Access Compliance Report Public Rights-of-Way (RR Crossings)

Intersection ID: 10035376	Main Street: RAMA_RD	Location: N/A
ADA ID: 6F018EED08AE	Overall Compliance: No	Severity Score: 0.0
Codes/Mitigation Info/Possible Solution		Field Measurements/Component Compliance

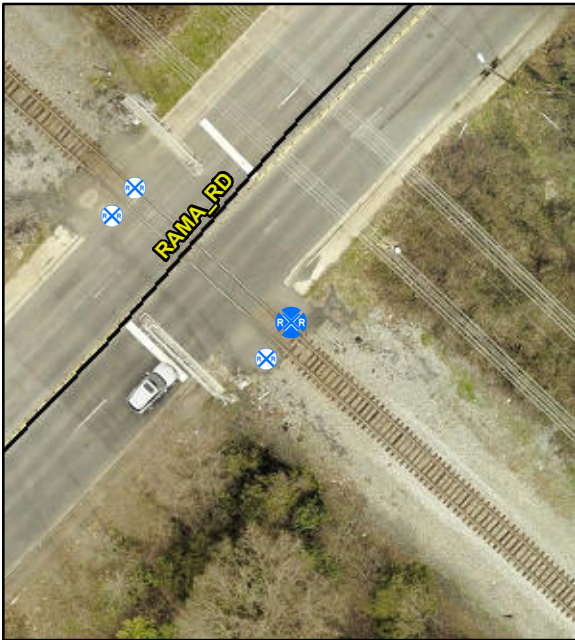
Compliance	Description	Data
No	DWS Provided?	No
N/A	DWS Contrast?	No
N/A	DWS Width (in)	No
N/A	DWS Length (in)	N/A
N/A	DWS Offset (in)	N/A
No	Pedestrian Gate?	No
N/A	DWS Outside Gate?	No
N/A	Rail Type?	Freight
No	Flangeway Gap (in)	3.0
Yes	Sidewalk Width (in)	60.0

**Install Detectable Warning System.
Provide Pedestrian Gate. Remove &
Replace Walking Surface Adjacent
to Rail.**
